FINDINGS AND RECOMMENDATION OFFICE OF PLANNING AND ZONING ANNE ARUNDEL COUNTY, MARYLAND

CASE NUMBER: 2023-0169-V COUNCIL DISTRICT: 3rd

The applicants are requesting a variance to allow boat lift pilings (two) with less setbacks than required on property located at 286 Riverside Drive in Pasadena.

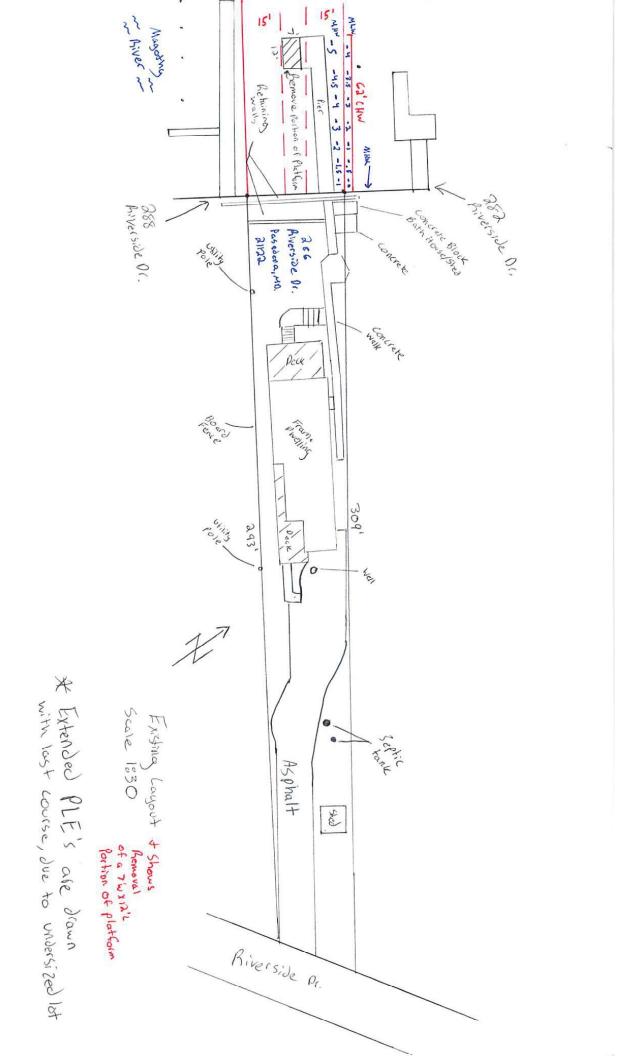
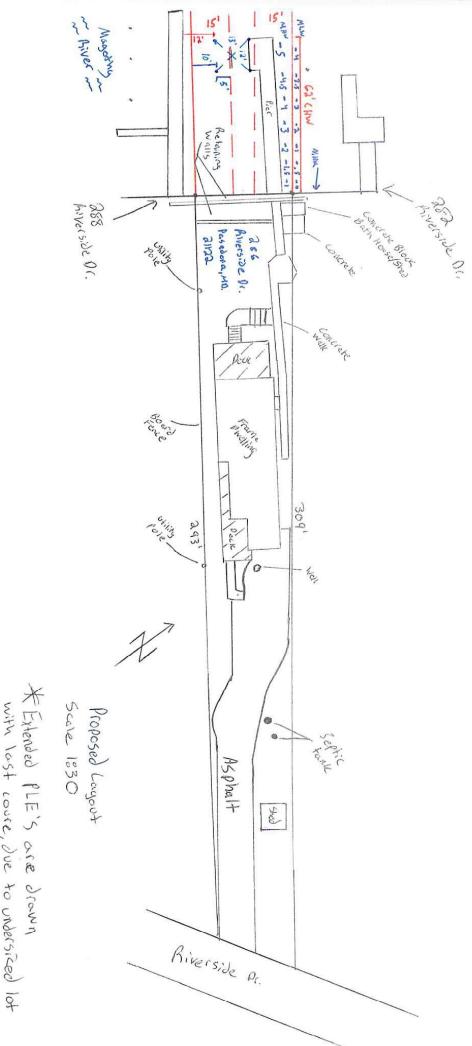
¹ The Critical Area Team's pier permit reviewer commented that the southwestern side lot line extension is not drawn correctly. The extension should be drawn to be parallel with the adjacent pier to the southwest. Therefore, the requested variance has been adjusted accordingly.

The **Development Division (Critical Area Team)** commented that the site plan is drawn according to the shoreline as shown on Plat 9, page 43, which includes +/- 40' linear feet of shoreline. The south property line extension (PLE) could be drawn more accurately as generally parallel to the adjacent pier. As such, the variance request may be more in line with a variance request of six feet rather than the five feet requested; however, this is minimal and there appears to be no significant impact. The Critical Area Team has no objection to this proposal.
